TECHNICAL SERVICE BULLETIN

Difficulty Unlatching Or Latching And/Or Locking Or Unlocking Doors - Built On Or Before 7-Jun-2020

21-2275
19 August
2021

Ford 2018-2020 Expedition
Lincoln 2018-2020 Navigator

Figure 1

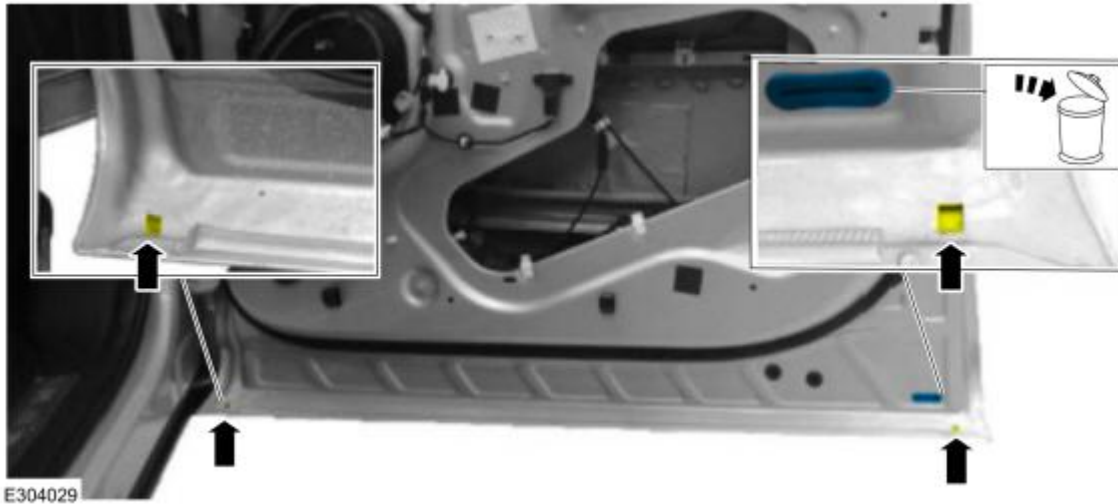
3. For all affected doors, remove and discard the rubber drain plug using a plastic trim tool. Using compressed air, clean obstructions, debris, foreign material and residual water from all door drain holes. (Figure 1)
